Architectural Control Committee  
Plan and Specification Review Determination  
Roofing Application

# AMBERLEIGH

SUBJECT: MINOR MODIFICATION TO AMBERLEIGH LANDSCAPE PLAN

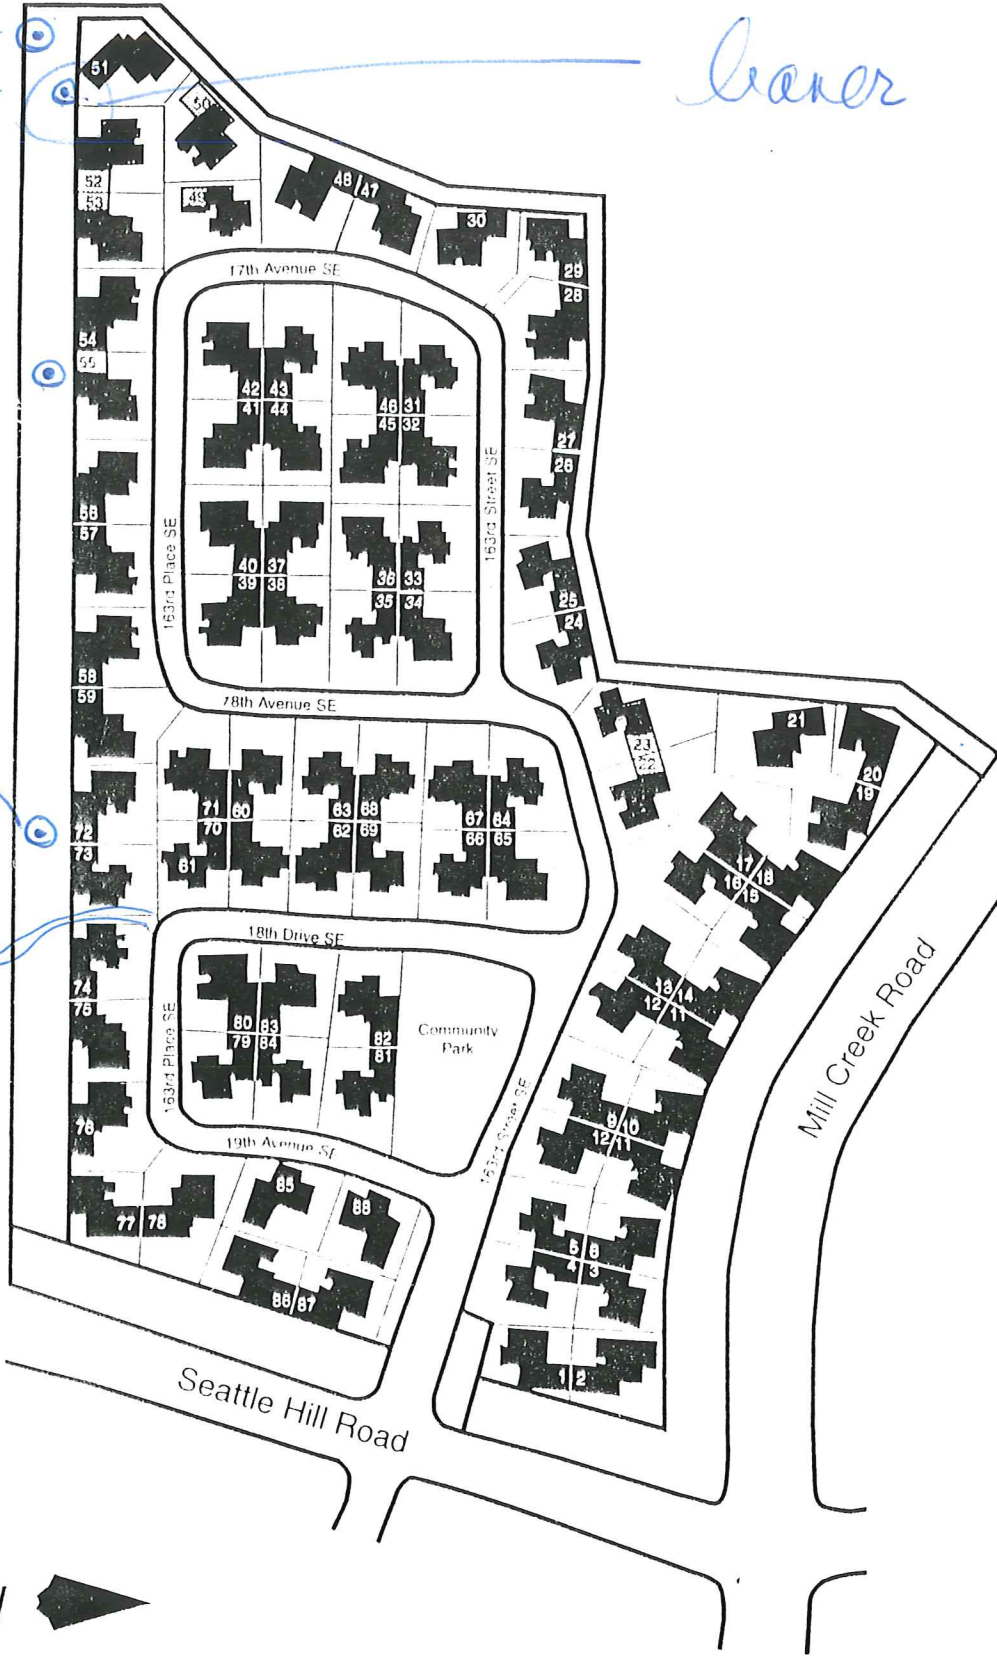
1 -  
2 -  
ok

leaner

3 -

leaner.

I talked to Bob W. Today. He plans to replace removed trees with 2 other trees in Amberleigh Subdivision. See note - Groll

Williamson says he's going to take down the two leaning trees next week. He says he won't hire an arborist and won't spend the money for replacement trees. Sheely

Trees are small dia, tall and leaning. Removal will not affect aesthetics of neighborhood since there are quite a few trees around these two. I believe these two trees could fall into homes in a storm. Need to plant two replacements in neighborhood. See U. 4/14/99 OK-S.N.

YOUR REQUEST TO REMOVE 4 TREES SOUTH OF AMBERLEIGH  
ON COMMON AREA IS REJECTED FOR TREES IDENTIFIED AS 1,  
2 AND 4 UNTIL AN ARBORIST INDICATES THAT THEY ARE DANGEROUS.  
TREE NUMBER 3 MAY BE CUT WITHOUT A REPLACEMENT TREE  
REQUIRED. THE ARCHITECTURAL CONTROL COMMITTEE POLICY IS  
DETAILED AT THE TOP OF THE TREE CUTTING PERMIT FORM, IT  
SAYS, "REMOVAL OF A NATIVE EVERGREEN WILL REQUIRE REPLACEMENT  
WITH AN EVERGREEN" THE REPLACEMENT TREES MUST BE 8-10 FOOT  
TREES BUT MAY BE PLANTED AT LOCATIONS DIFFERENT THAN THOSE  
CUT. WAIVERS ARE Seldom GRANTED AND MUST HAVE <sup>AN</sup> EXTRAORDINARY  
REASON.

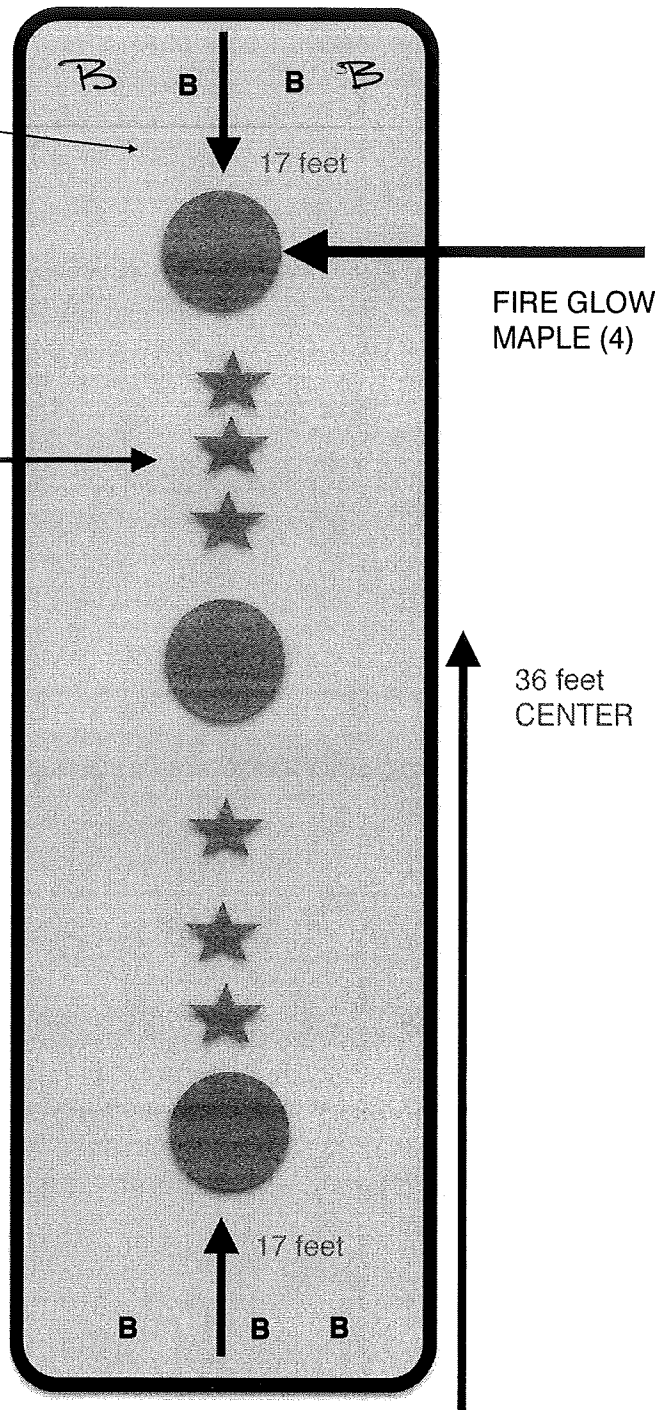
THIS IS THE PLANTING IDEA, THE AREA WILL  
HAVE AN APPROPRIATE NUMBER OF PLANTS  
TO MAKE IT LOOK GREAT

The proposed plan has been reviewed in comparison to the original approved plan, which consisted of four *Pyrus calleryana* 'Chanticleer' street trees, *Ilex crenata* 'Helleri' shrubs and lawn. The replacement plan proposes four *Acer Palmatum* 'Fireglow' street trees, *Rhododendron* 'Songbird' and *Berberis thunbergii* 'Pow Wow' shrubs. For maintenance purposes, the plan proposes mulch in place of the lawn.

The plan is similar to the original with street trees and shrubs, just a different species. The Amberleigh HOA has stated that one of the reasons for the change was problems caused by the wider growth habit and relatively low branches of the original trees, which were regularly damaged by taller vehicles such as garbage trucks. The proposed street tree species, which is a Japanese maple, is on the City's Approved Street Tree list, and has a more columnar growth habit, which should eliminate the conflicts with vehicles.

Since the proposed minor modification to the landscape plan does not: (a) negatively affect the overall project character, (b) increase the number of dwelling units, or intensity of use, or (c) decrease the quality or amount of required landscaping or open space, the replacement plan is

Proposed Construction Drawing  
(Property Sketch):

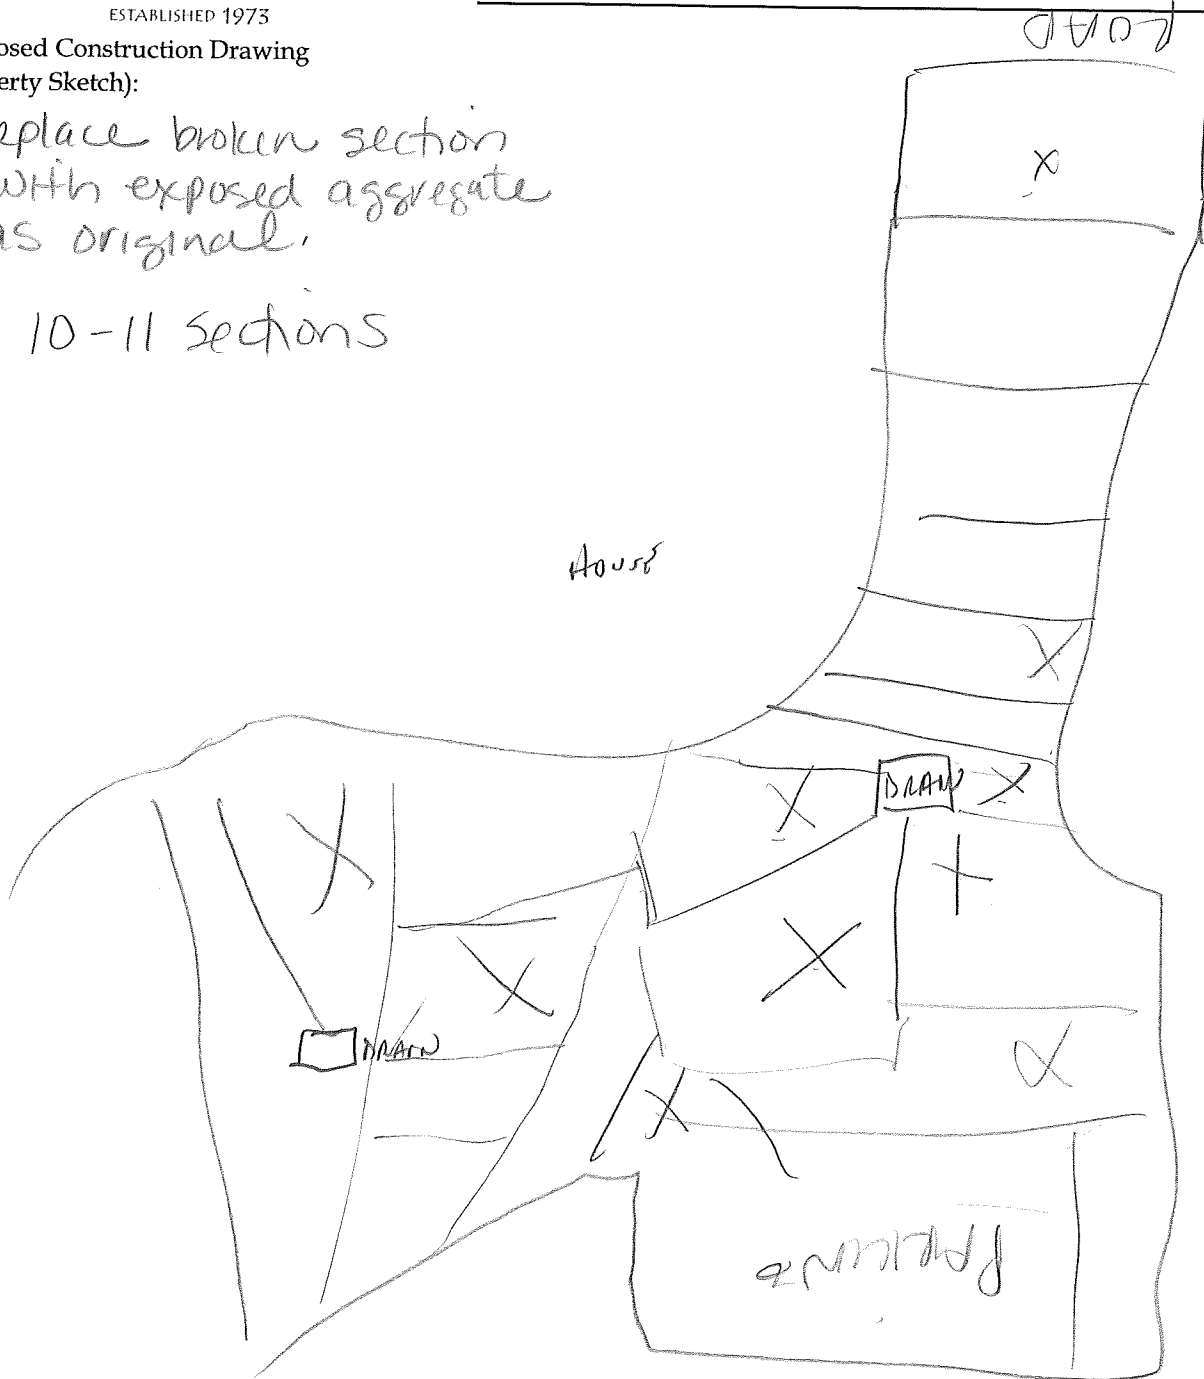
Replace broken section  
with exposed aggregate  
as original.
